AIRWORTHINESS DIRECTIVE

No. 2024-53-D-03

Scope: D-136 type and series 1 D-136 engines

APPROVED		
		by Chief Structural Engineer of the Federal State Unitary		
		Enterprise GosNII GA (GosNII GA Scientific Center for		
		Continuing Airworthiness of Aircraft, SC CAA)		
				M.S. Gromov
		February 15, 2024		
TECHNICAL DECISION		Introduction of corrective actions in order to avoid destruction of the upper horizontal shaft (UHS) 136.06.00.102-01 of D-136 engines in Mi-26T helicopters registered in the State Register of Civil Aircraft of the Russian Federation		
		No. 7.TRZ. 136.4.8-23/538		
		Revision No. 01		
AERONAUTICAL PRODUCT TYPE		D-136 engine		
		all modifications		
Stages	Job title	Full name	Signature	Date
Originated by	Head of Department No. 156	Uvaev S.F.		Feb. 12, 2024
Checked by	Deputy Head of Department No. 156	Yurin S.P.		Feb. 12, 2024
Agreed by	Head of Service - Expert of Service No. 155	Arepyev K.A.		Feb. 15, 2024

Fig. 1. Drive of the upper horizontal shaft

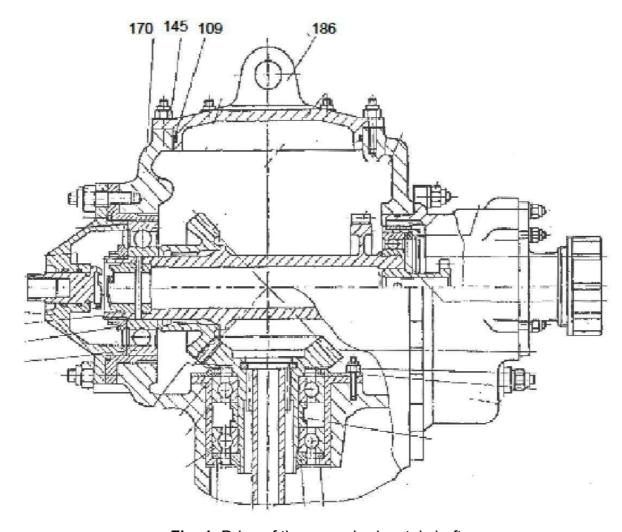
- 1. Remove the hoisting eye 186 in the following order:
- using a 10 mm socket wrench, unscrew the fastening nuts 145 (Fig. 1) of the hoisting eye 186:
- carefully remove the hoisting eye, paying special attention to the integrity of the O-ring 109:
- using backlight, inspect the UHS 136.06.00.102. This inspection may produce two possible cases as a result: the presence or absence of compensation holes in the hub surface of the UHS 136.06.00.102-02.

- 3. Observing the safety measures set out in section 72.00.02 of the OM, install the hoisting eye 186 (Fig. 1) on the flange of the intermediate housing 170 (Fig. 1) in the following order:
- using a magnifying glass ×10, check the condition of the O-ring 109 (Fig. 1). Cracks, abrasions and deformations are not allowed.

- carefully place the O-ring 109 on the hoisting eye 186, avoiding its twisting;
- using backlight, make sure that there are no foreign objects in the main drive cavity;
- install the hoisting eye 186 on the flange of the main drive housing. When installing O-ring 109 (Fig. 1), carefully control the alignment of the holes in O-ring 109 with the studs on the flange of the main drive housing. Foreign particles must not adhere to the O-ring 109; delamination of the material of the ring 109 and misalignment of the holes with the corresponding studs of the flange of the main drive housing 170 are not allowed;

- use a torque wrench U5353-0107 to secure the hoisting eye 186 with the nuts 145 (Fig. 1). The tightening torque of the nuts shall be 0.8 - 1.0 kgf-m.

Fig. 2. Upper horizontal shaft 136.06.00.102-02

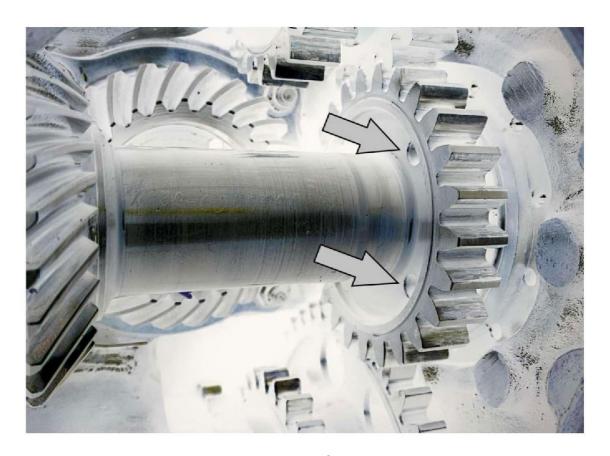
NOTE. The presence of compensation holes in the UHS hub surface (shown by arrows in Fig. 2) indicates that this is a reinforced UHS 136.06.00.102-02.

Fig. 3. Location of the hoisting eye on the upper box-shaped boss

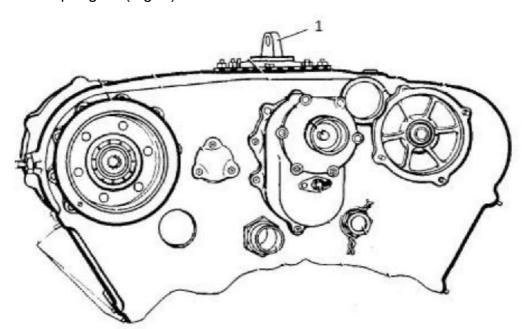
- 1. Remove the hoisting eye 186 (Fig. 1) in the following order:
- using a 10 mm socket wrench, unscrew the fastening nuts 145 (Fig. 1, Appendix 1) of the hoisting eye 1 (Fig. 3);
 - carefully remove the hoisting eye, paying special attention to the integrity of the O-ring 109.
- 2. Using a depth gauge, measure the distance (h) from the wall of the hub surface to the end of the spur gear (Fig. 4).

Fig. 4. UHS 136.06.00.102

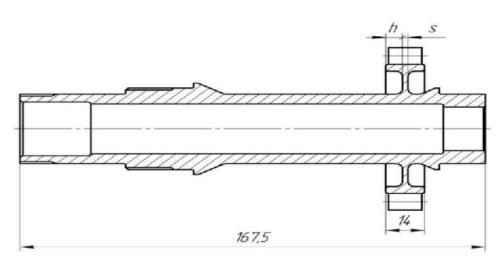
If the obtained value S < 6 mm, suspend operating the engine until the UHS is replaced with an enhanced modification 136.06.00.102-02 or 136.06.00.102-03.

If **S** ≥ **6 mm**, continue operating the engine in accordance with the OM within the established resource performance and service life of the engine and its components.

3. Determine the thickness of the hub surface (S) using the formula:

$$S = (7 - h) \times 2$$
